# DEVIATION REVIEW AND DECISION FORM

Subdivision or Project Name: Sterling Ranch  
Subdivision Filing No. 1

Section of ECM from Which Deviation is Sought: SD\_2-3 Urban Non Residential Collector Roadway Standard Cross Section Drawing.

(MODIFIED) URBAN NON-RESIDENTIAL COLLECTOR CROSS SECTION

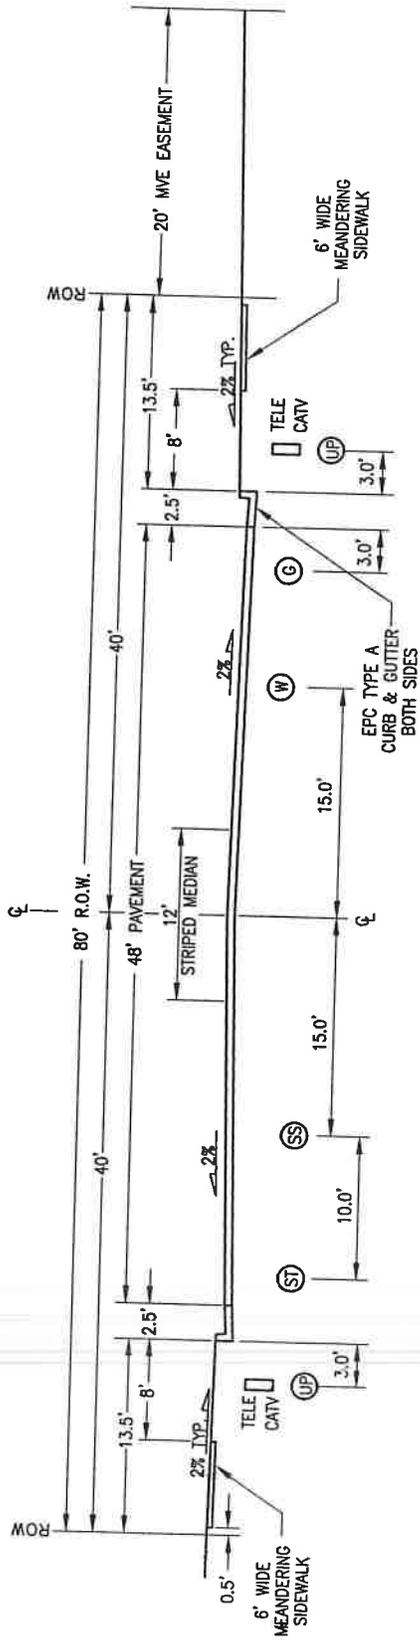
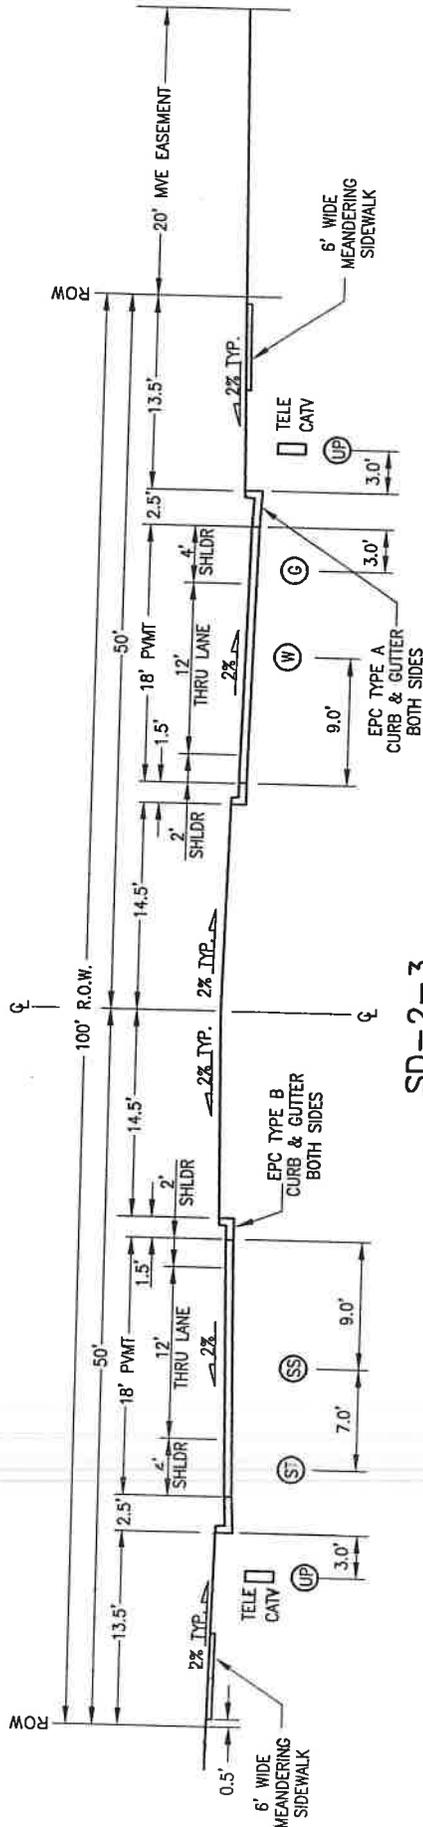
Specific Criteria from Which a Deviation is Sought: The use of a median entry feature (see attached exhibit) in the center area shown on the standard cross section as painted median.

Proposed Nature and Extent of Deviation: The proposed median entry feature (see attached exhibit) would be installed with the initial street construction, extending about 550 feet east of Marksheffel Road to the intersection of Bynum Drive and then continuing east an additional 200 feet of median for transitional purposes.

7. Additional Right-of-Way - Any additional right-of-way necessary to accommodate the medians shall be provided. The SD\_2-3 Urban Non Residential Collector Roadway Standard Cross Section Drawing requires a 80' ROW, whereas for the median entry way feature a 100' ROW is proposed and shall transition to an 80' ROW east of the proposed median.

This request has been determined to have met the criteria for approval. A deviation from Section SP 2-3 of ECM is hereby granted based on the justification provided. Comments:  
\_\_\_\_\_  
\_\_\_\_\_  
\_\_\_\_\_
